# Access Compliance Report

## Public Rights-of-Way (Curb Ramps)

Intersection ID: 32022	Main Street: FAIRWAY_VISTA_DR	Cross Street: GREENWAY_BEND_DR	Location: S
ADA ID: B00FAB64B0FA	Ramp Type: Perp	Initial Pass/Fail: Fail	Overall Compliance: No
Codes/Mitigation Info/Possible Solution		Field Measurements/Component Compliance	
Severity Score: 25

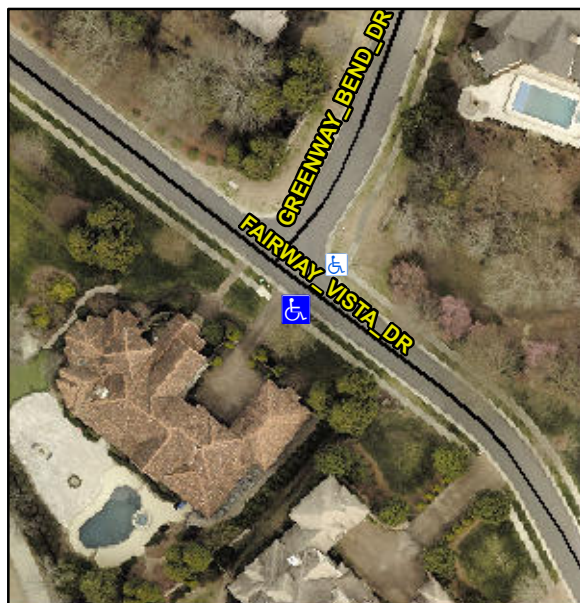
**Not Found, R304.5.3**

Compliance	Description	Data	Compliance	Description	Data
N/A	Ramp Length (in)	49.0	Yes	Ramp Slope (%)	5.6
Yes	Ramp Width (in)	49.0	No	Ramp XSlope (%)	10.8
N/A	Flare Type LT	N/A	N/A	Flare Type RT	N/A
N/A	Flare Slope LT (%)	N/A	N/A	Flare Slope RT (%)	N/A
N/A	Flare Traversable LT?	N/A	N/A	Flare Traversable RT?	N/A
N/A	Landing Length (in)	N/A	N/A	DWS Provided?	N/A
N/A	Landing Width (in)	N/A	N/A	DWS Contrast?	N/A
N/A	Landing Slope (%)	N/A	N/A	DWS Length (in)	N/A
N/A	Landing X Slope (%)	N/A	N/A	DWS Full Width?	N/A
N/A	Landing Curb? (Y/N)	N/A	N/A	DWS Offset (in)	N/A
N/A	Shared Landing?	N/A			
N/A	Gutter Ponding?	N/A	N/A	Gutter Slope (%)	N/A
N/A	Gutter Lip Ht (in)	N/A	N/A	Gutter X Slope (%)	N/A
N/A	Painted X Walk1?	No	N/A	Painted X Walk2?	N/A
	X Walk 1 Direction	To NE		X Walk 2 Direction	N/A
N/A	X Walk 1 Width (in)	N/A	N/A	X Walk 2 Width (in)	N/A
	X Walk 1 Slope (%)	2.6		X Walk 2 Slope (%)	N/A
	X Walk 1 X Slope (%)	7.5		X Walk 2 X Slope (%)	N/A

**Remove & Replace Entire Ramp.**
